Re: Revised 410 Kingsland Avenue Monitoring Well Network Modification Request
ExxonMobil Greenpoint Petroleum Remediation Project
Greenpoint, Brooklyn, New York

Roux Environmental Engineering and Geology, D.P.C. ("Roux"), on behalf of ExxonMobil Oil Corporation (ExxonMobil), has prepared this letter report (Report) to request New York State Department of Environmental Conservation (NYSDEC) approval of monitoring network modifications within the 410 Kingsland Avenue (410 Kingsland) property associated with the ExxonMobil Greenpoint Petroleum Remediation Project (EMGPRP).

ROUX	Compiled by: J.C.	Date: 06/17/25	FIGURE 1
	Prepared by: M.S.R.	Scale: AS SHOWN	
	Project Mgr: C.L.	Project: 0172.0030Y113	
	File: 0172.0030Y5268.1.mxd

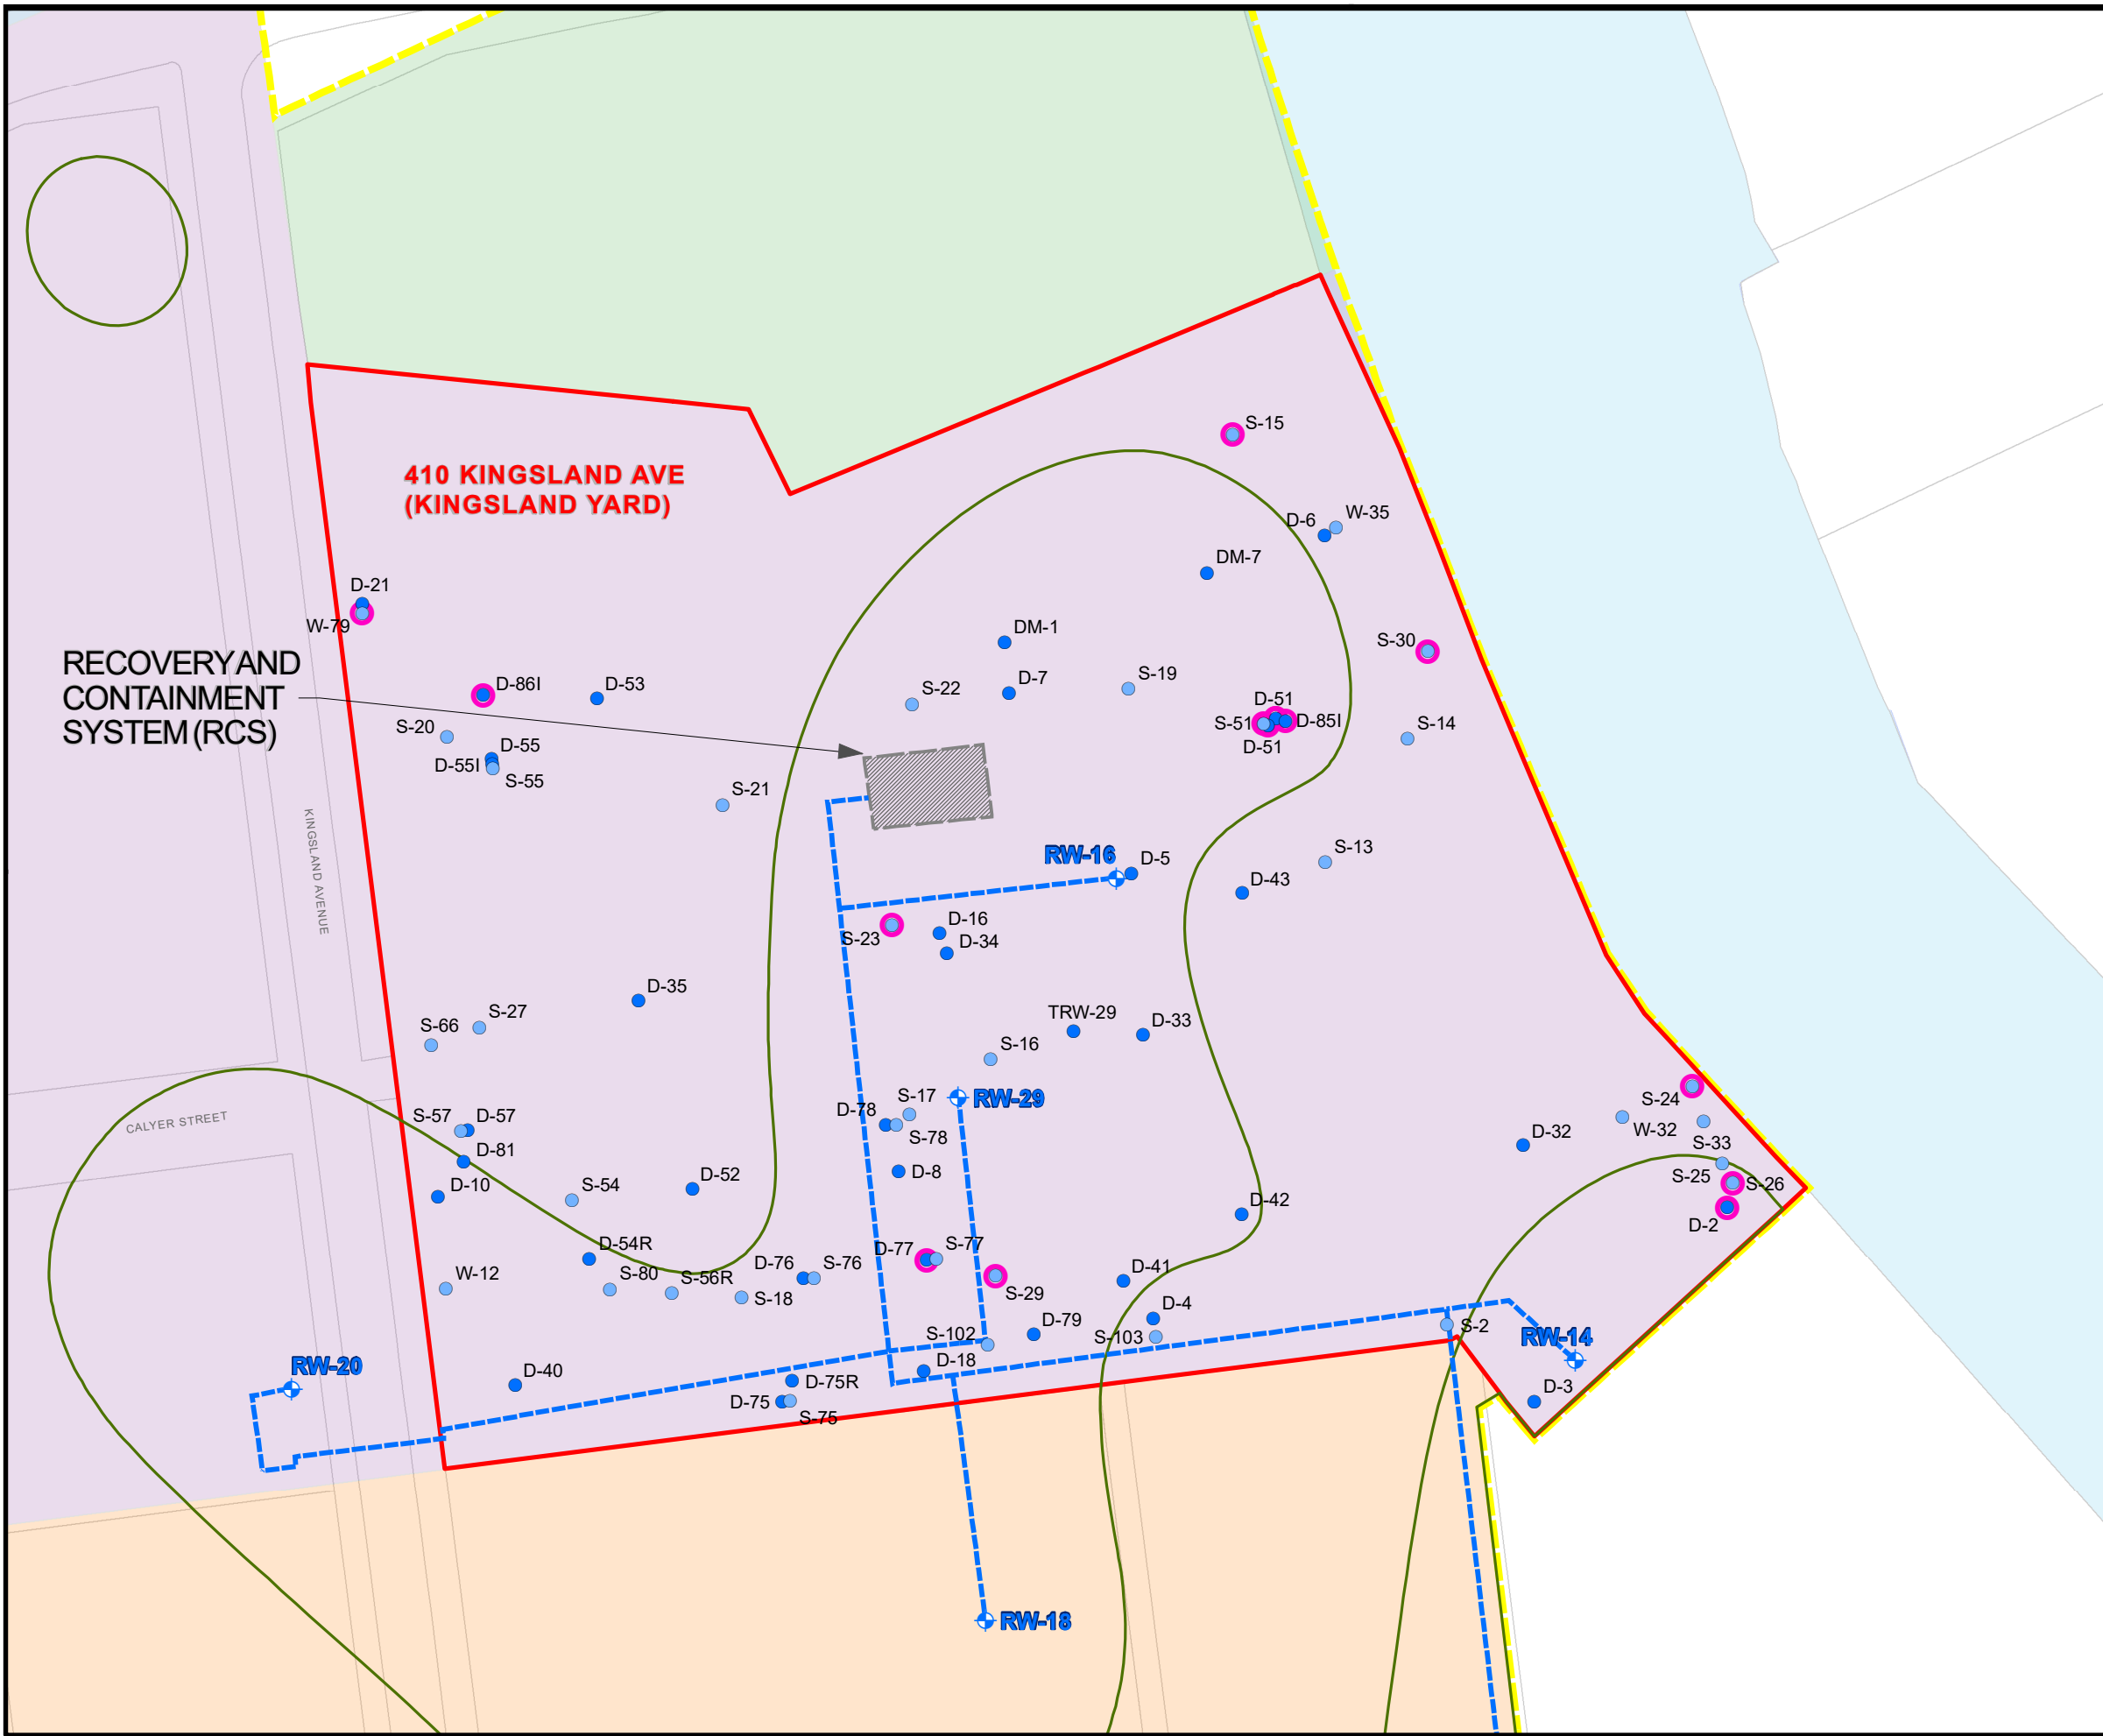
In addition to the existing 410 Kingsland monitoring wells currently being utilized during quarterly fluid-level monitoring events, it should be noted that 14 of the 73 existing 410 Kingsland monitoring wells are currently part of the annual groundwater sampling network, as detailed in Figure 1. During Phase 2 redevelopment activities, the annual groundwater sampling network would temporarily be reduced from 14 monitoring wells to five monitoring wells (S-15, S-105 [replacement for S-30], S-24, S-25 [replacement for S-26], and D-2), as shown on Figure 3. These five monitoring wells were strategically selected to ensure continued groundwater monitoring along Newtown Creek. Following redevelopment activities, a total of ten monitoring wells out of the 14 existing monitoring wells in the annual groundwater sampling network are expected to be maintained, reinstalled, or replaced by equivalent monitoring wells in the proposed new monitoring well network, as detailed in Table 3. The proposed new groundwater sampling network within the 410 Kingsland property is depicted on Figure 4. The four monitoring wells proposed for removal from the annual groundwater sampling network, without replacement, as a result of the 410 Kingsland monitoring well network modifications are S-51, D-51I, D-85I, and D-86I. The rationale for removal of these four wells from the annual groundwater sampling network is provided below and in Table 3.

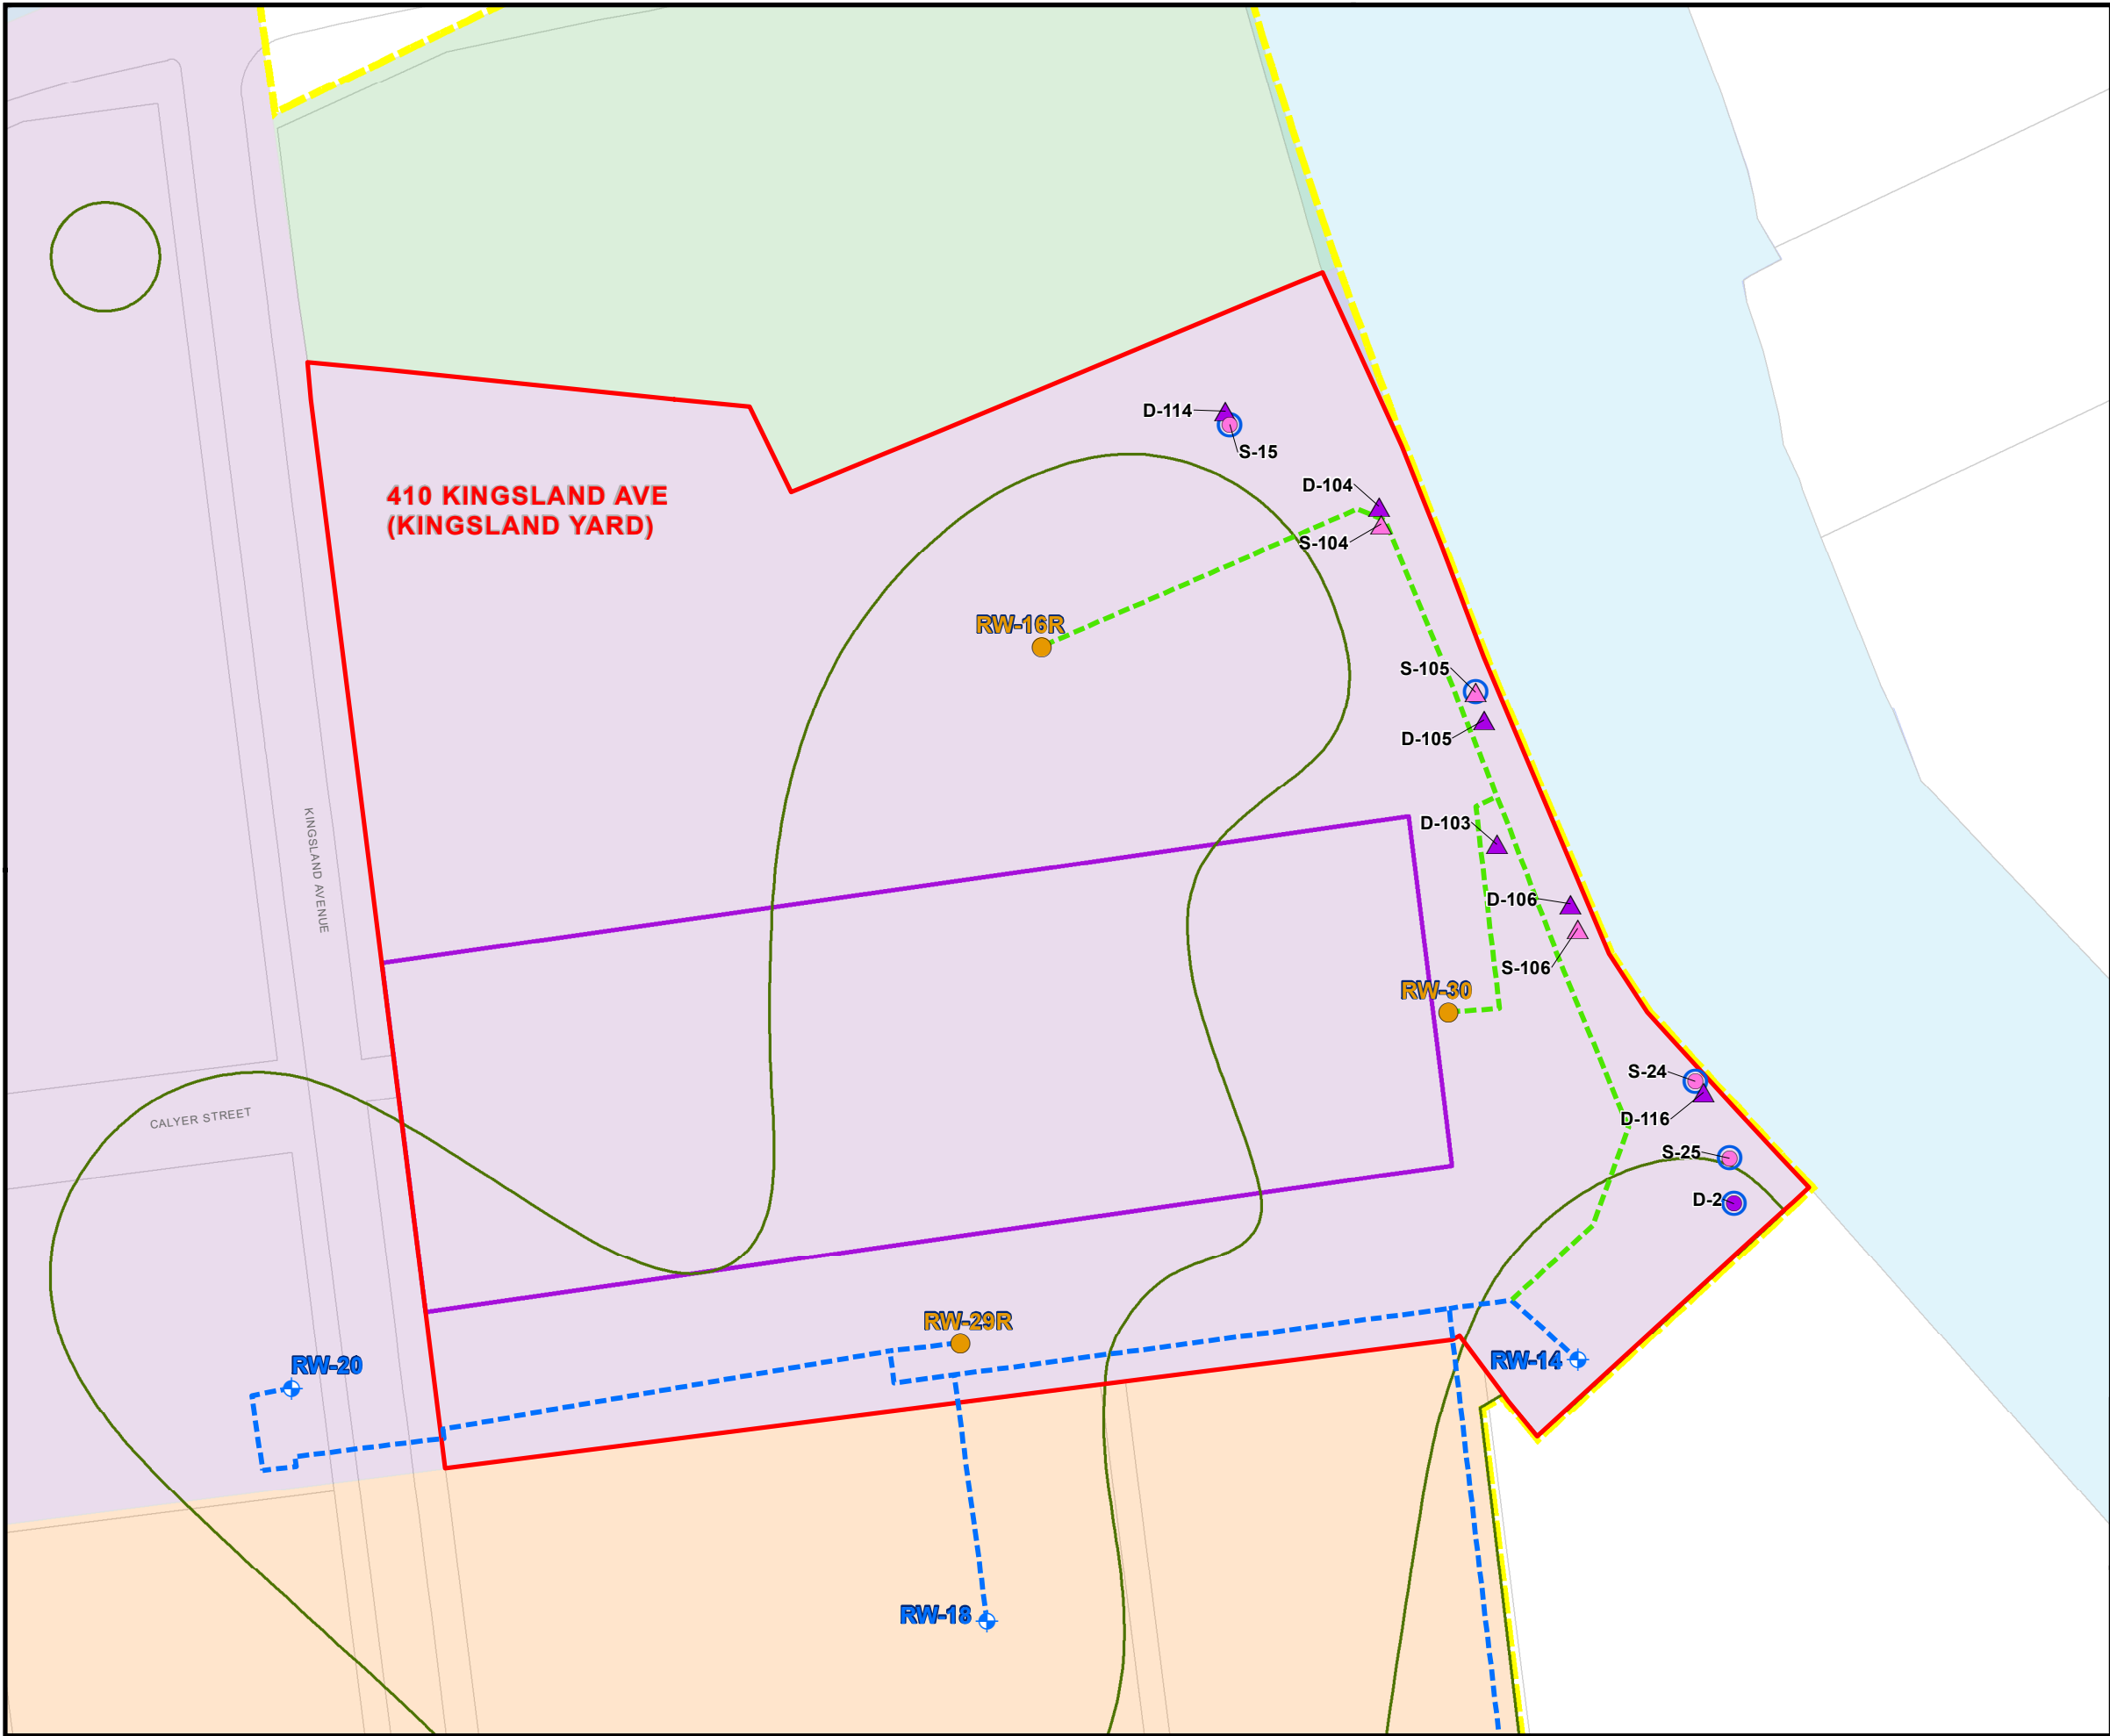
In addition to the monitoring well network modifications proposed above, recovery wells RW-16 and RW-29 (Figures 1 and 2) are anticipated to be relocated to locations RW-16R and RW-29R, as depicted on Figures 3 and 4. The recovery well relocation activities will be performed in accordance with the Recovery Well RW-16 and RW-29 Relocation Request letter dated September 18, 2023 and the related response to comments letter dated April 12, 2024 and approved by the NYSDEC in a letter dated June 6, 2024. Further clarifications regarding an alternative location for RW-16R were provided to the NYSDEC in an email correspondence dated November 18, 2025 which was approved by the NYSDEC in an email dated November 20, 2025 (Attachment 1).

1. THE ANTICIPATED RELOCATION OF RW-16, RW-29, AND THE ASSOCIATED GROUNDWATER REMEDIATION SYSTEM PIPING WAS APPROVED BY THE NEW YORK STATE DEPARTMENT OF ENVIRONMENTAL CONSERVATION IN THE RECOVERY WELL RW-16 AND RW-29 RELOCATION REQUEST APPROVAL LETTER DATED JUNE 6, 2024. RW-30 IS INCLUDED AS A CONTINGENCY FOR FUTURE INSTALL, IF DETERMINED NECESSARY FOR HYDRAULIC CONTROL.
2. IF ANY OF THE EXISTING MONITORING WELLS ASSOCIATED WITH PHASE 2 OF THE 410 KINGSLAND MONITORING WELL NETWORK ARE DESTROYED DURING THIRD-PARTY REDEVELOPMENT ACTIVITIES, THEY WILL BE REINSTALLED IN A COMPARABLE LOCATION. REPLACEMENT WELLS WILL BE NAMED UTILIZING THE ORIGINAL WELL NAME WITH AN "R" AT THE END (I.E., D-2 WOULD REINSTALLED AS D-2R)
